PRODUCT  
SUPPORT  
BULLETIN # 440

TOOL(S) \ PRODUCT(S) AFFECTED : 5359 21, 5360-21 SDS 1-1/8" Rotary Hammer

**SUBJECT:** pressing of Intermediate Gear Set onto Armature pinion shaft... binding / screaming / very noisy

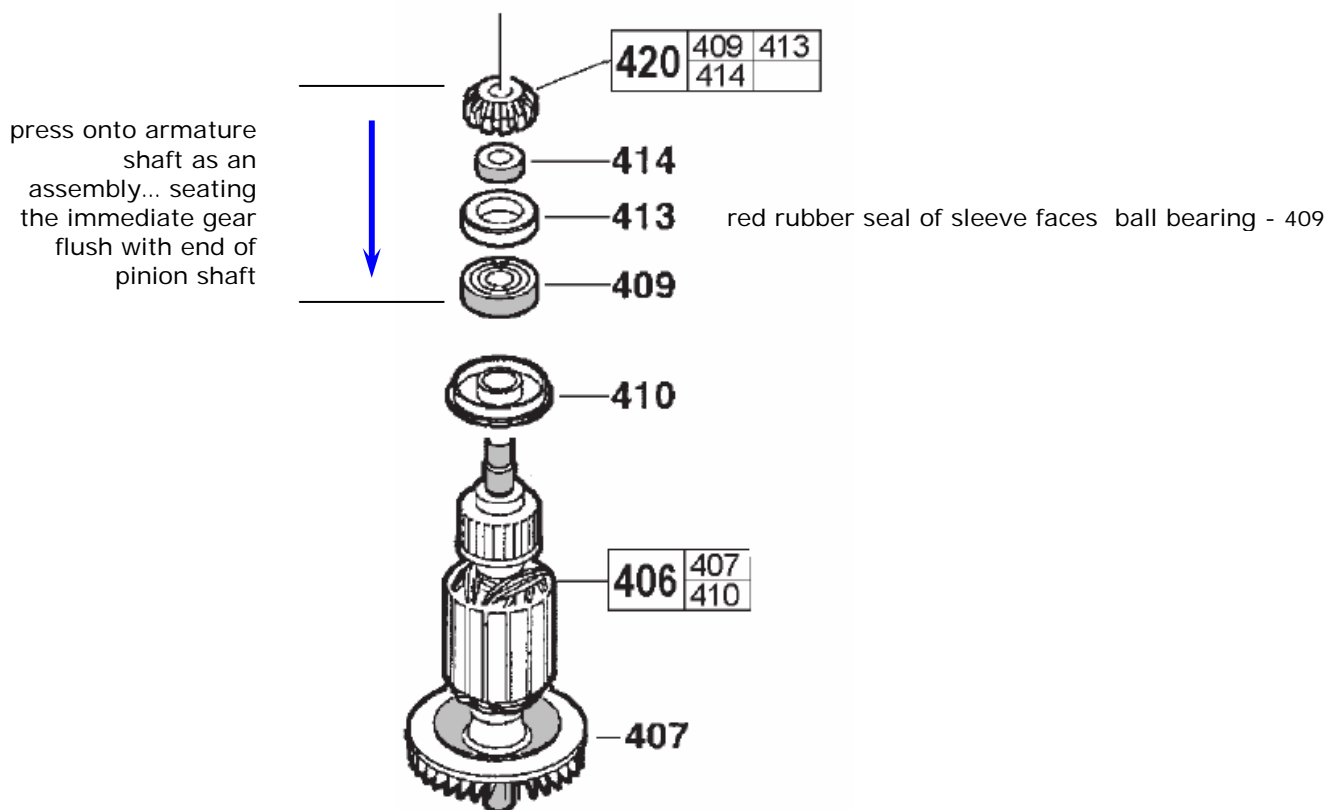
**SERVICE NOTE!** Intermediate Gear of Intermediate Gear Set [fig. 420] presses down flush to the top of the armature pinion against Spacer [fig. 414], Sleeve [fig 413] and Ball Bearing [fig. 409]. If the tool is binding / screaming / very noisy the problem could be the spacing / position of the ball bearing [fig 409] in the assembly. The armature pinion shaft does not have a shoulder or retainer for the ball bearing to stop against. Remove **ONLY** Intermediate Gear Set assembly [fig. 420] from armature - leaving Insulating Disc [fig. 410] in place and repress the ball bearing, spacer, sleeve and bevel gear onto the armature shaft **ALL** at the same time; allowing the ball bearing to **self-space / self-position** itself on the pinion shaft.
